HUALAPAI INDIAN NATION  
PEACH SPRINGS, ARIZONA  
RFP FOR COMMUNITY-SCALE SOLAR FEASIBILITY STUDY

Pre-Submittal Questions and Answers on Request for Proposal for Consultants issued on February 23,  
2017

**ADDENDUM NO. 3**

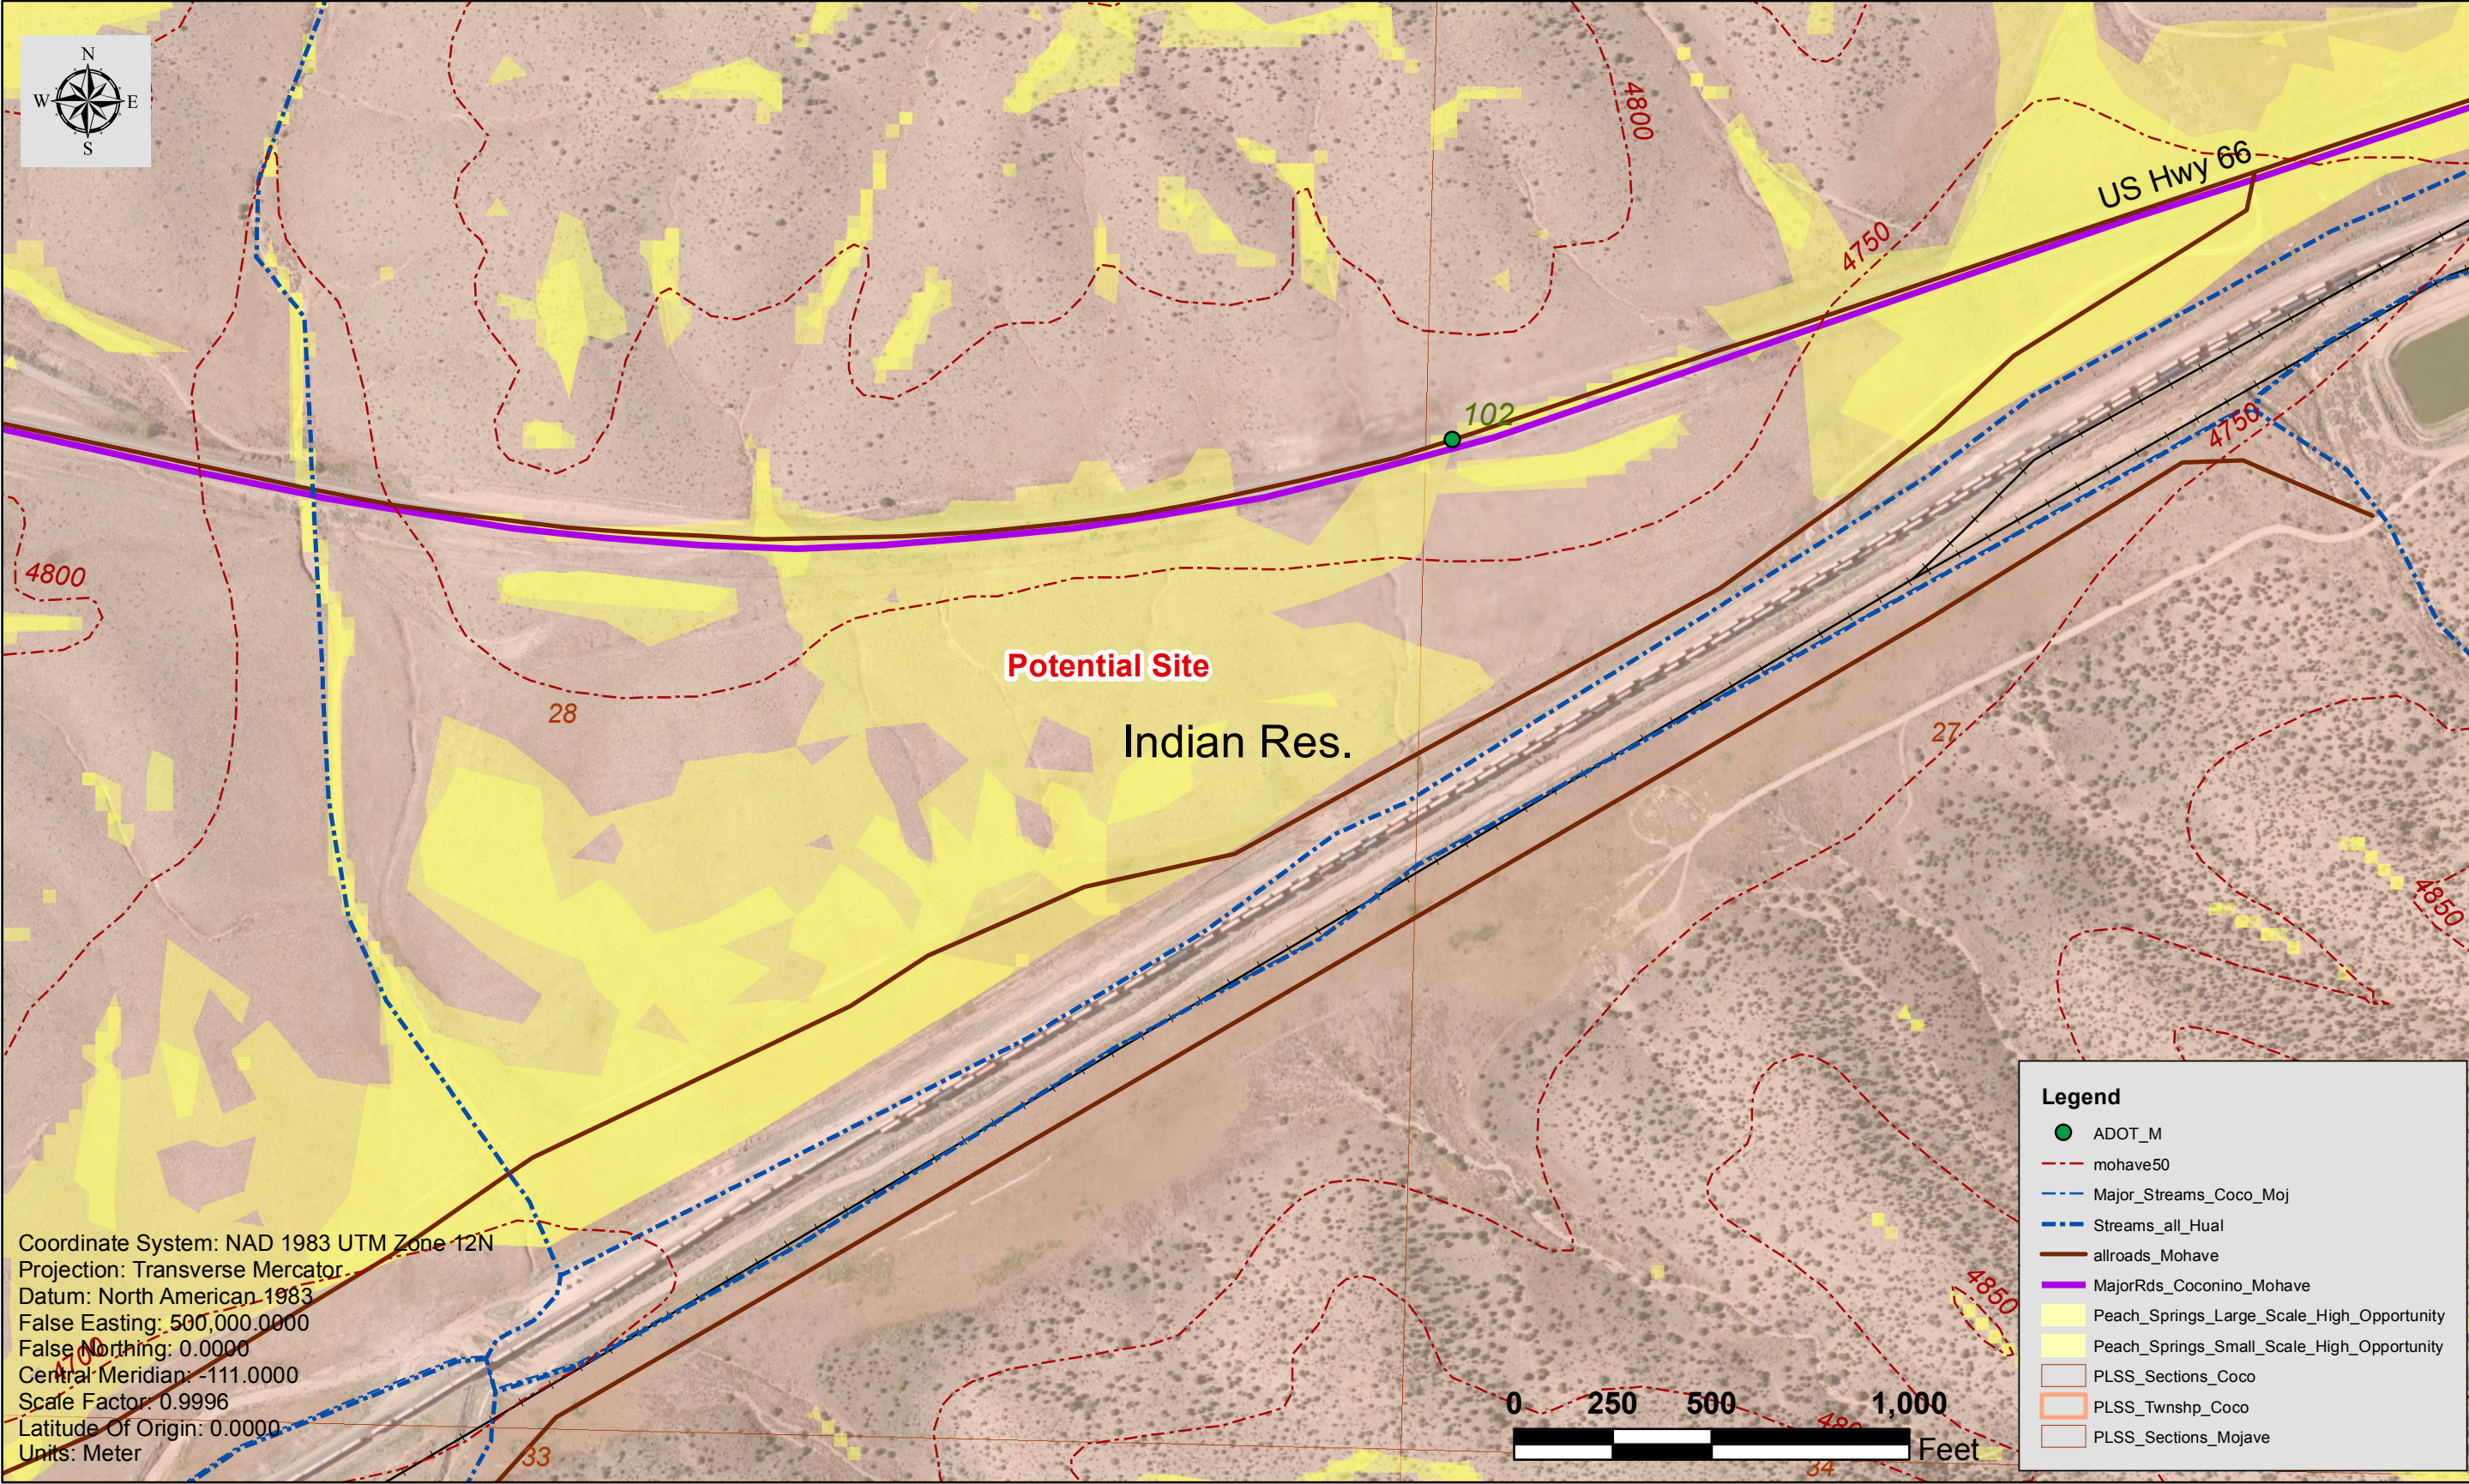
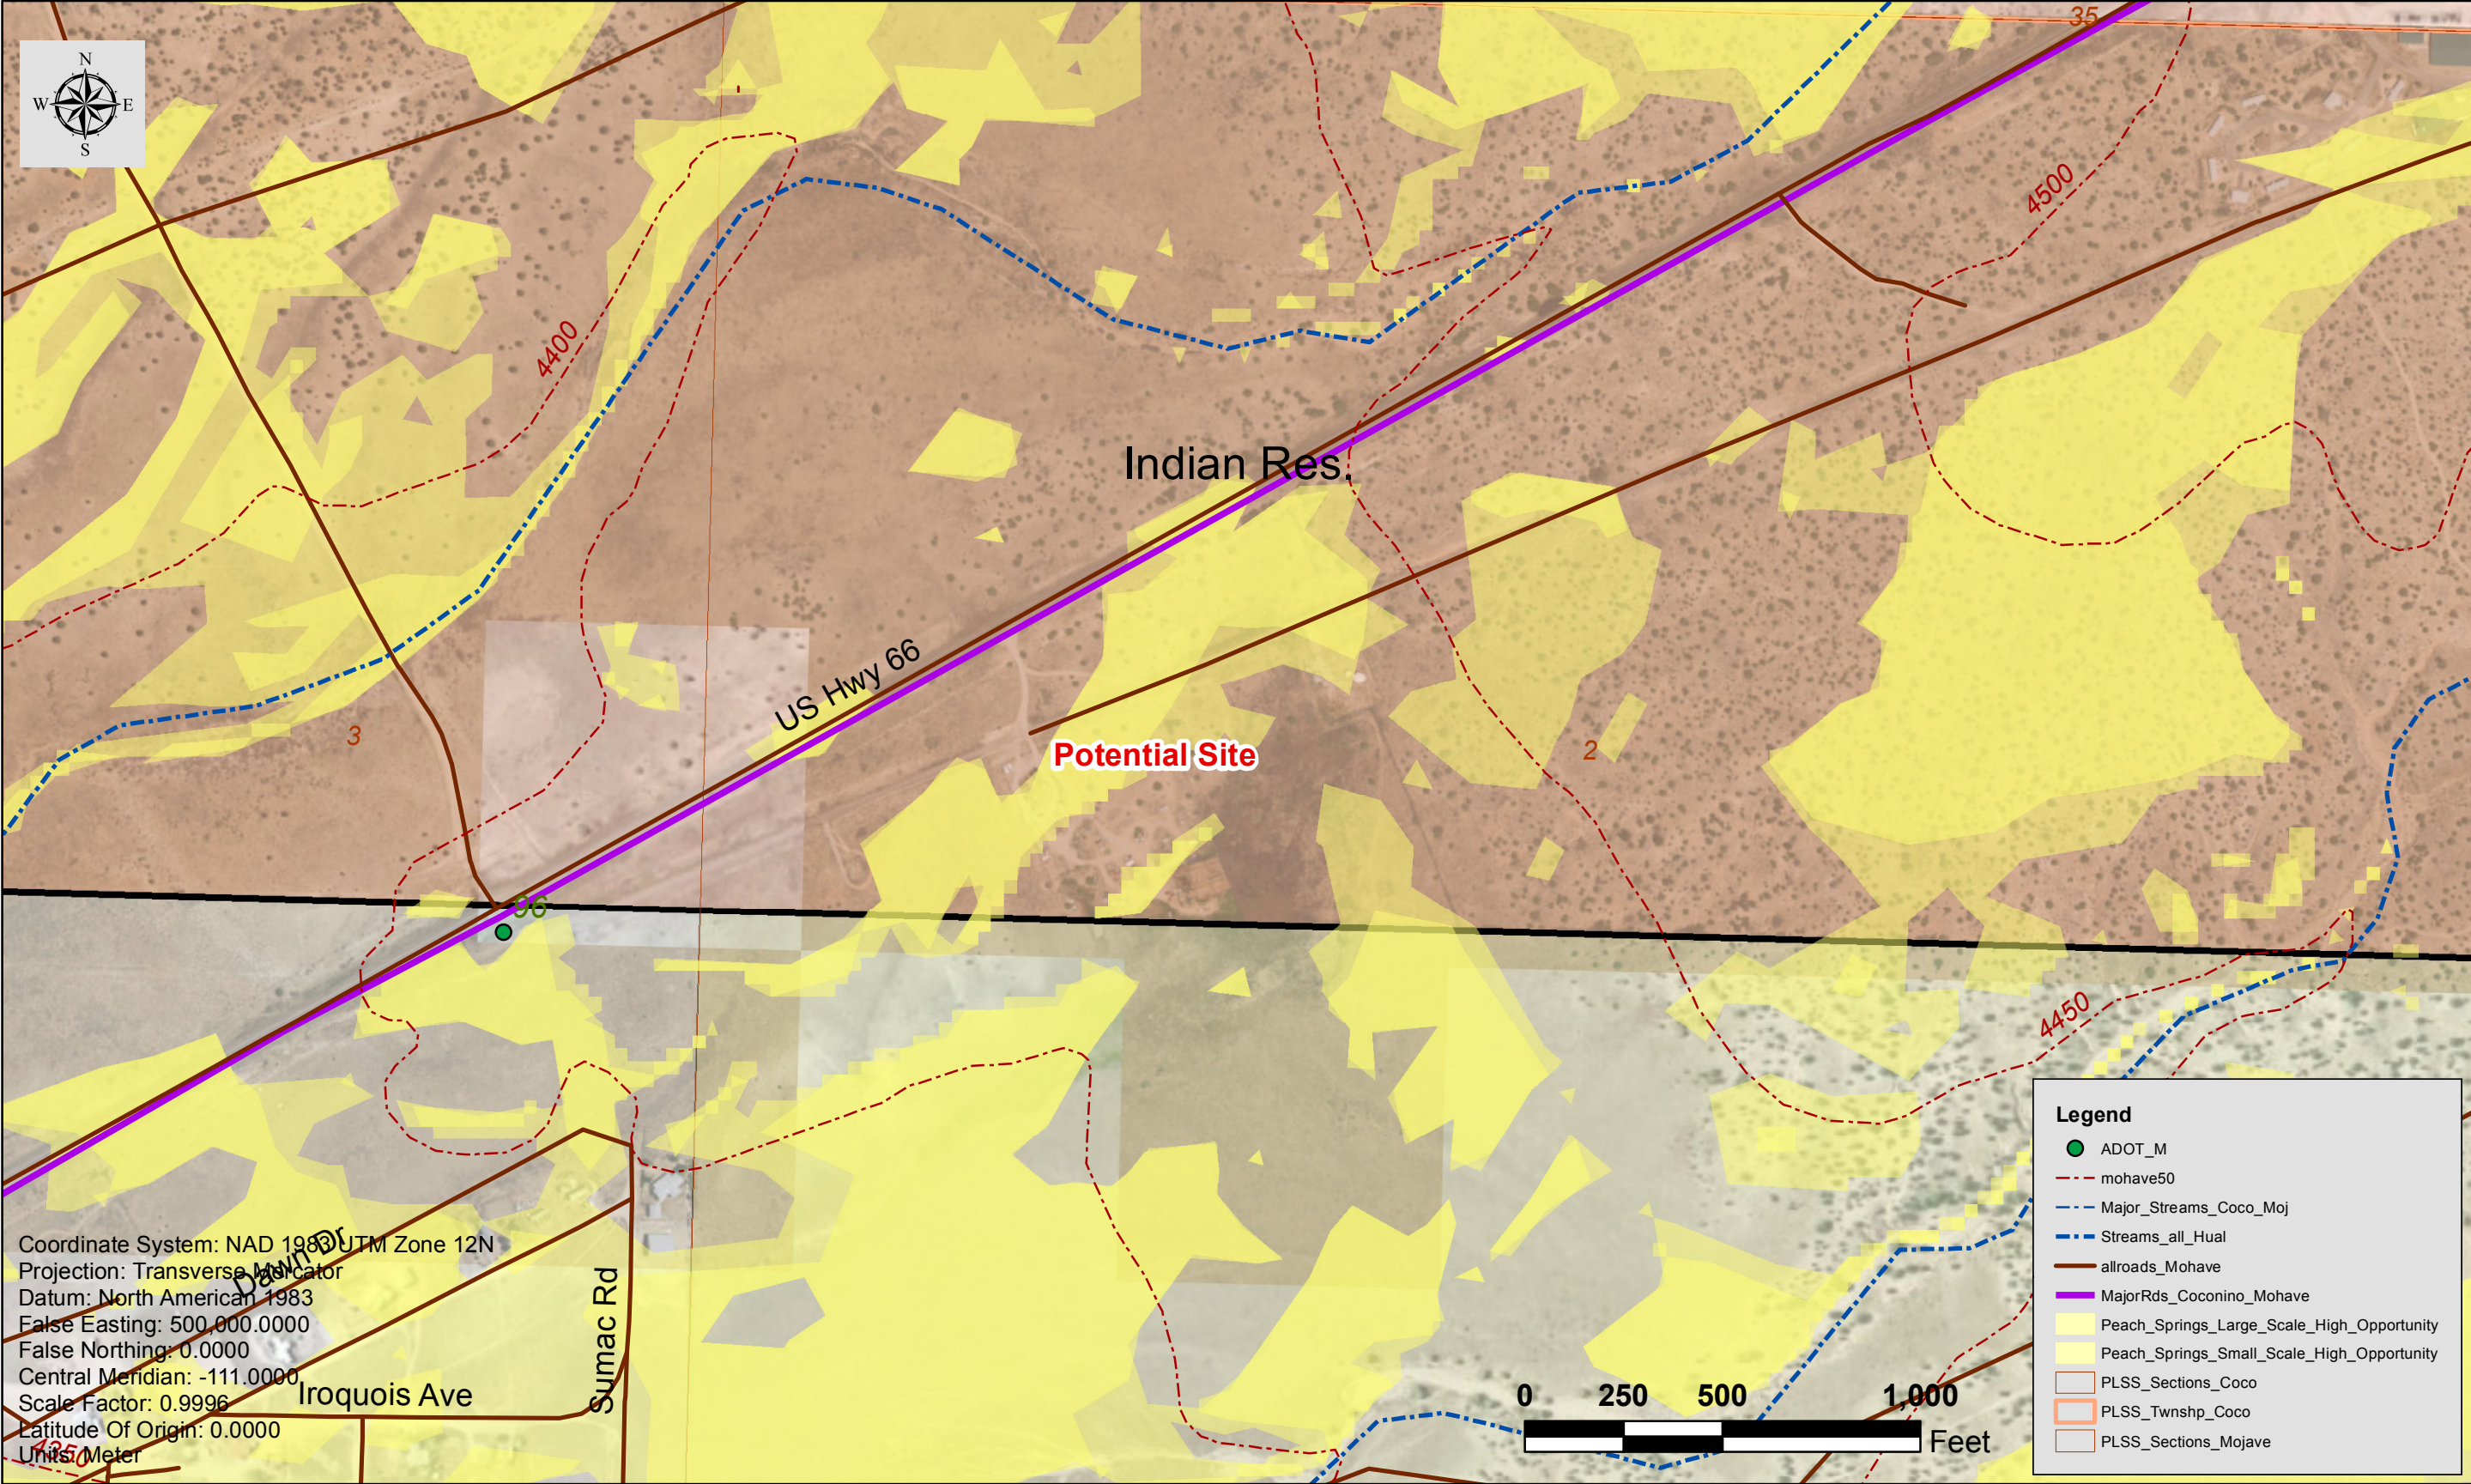
- 1) To estimate solar facility costs as part of evaluating site feasibility, topographic surveys for each of the three potential sites are needed.
  - a) *Can HTUA provide topographic surveys for each of the potential sites for use in preparing a response to the RFP?* Please see attached 50' contour maps. Maps also show solar potential based upon the 2013 Renewable Energy Opportunity Analysis performed by the University of Arizona.

- b) *If topographic surveys are not available, can HTUA provide a site plan showing site boundaries with GPS coordinates?* Please see attached 50' contour map. Part of the feasibility study will require the consultant to locate a particular site location for the array.

- c) *Can HTUA provide a site map showing the location of the nearest Mohave Electric Cooperative 24.9kV line and nearest improved road?* Please see attached 50' contour map, the Certificate of Convenience & Necessity (see Attachment G, page 42) and the e-mail link (.kmz) provided by MEC for the 24.9 KV route between Peach Springs and Nelson.
